Collective response

Notes on figure 1:

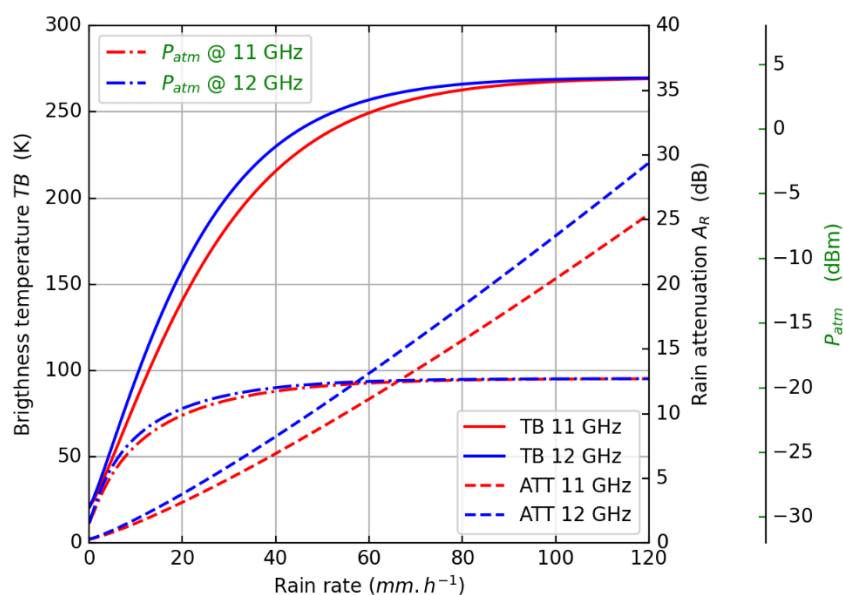
- Fig 1: It is good to see P_{atm} in this plot now. One minor, but important, improvement would be to use the same scaling for A_r and P_{atm} on the two y-axis, because these are the two „competing“ processes and it would be easier to judge which process is the dominating one at which rain rates. P_{atm} could also be scaled so that it starts at the bottom of the plot for zero rain rates.
- the authors should add in Fig 1's caption and in the text how Fig 1 was obtained (from simulations I guess - but it should be clarified)

Answer : done

Caption: *Simulated* sky brightness temperature TB (solid lines), atmospheric induced power P_{atm} at the LNB output (dashed-dotted lines) and atmospheric attenuation (dashed lines) at 11 and 12 GHz for a zenith angle of 45° , with a zero isotherm at 3 km as a function of rain rate for a standard commercial TV-SAT LNB (1 GHz bandwidth, 65 dB gain).
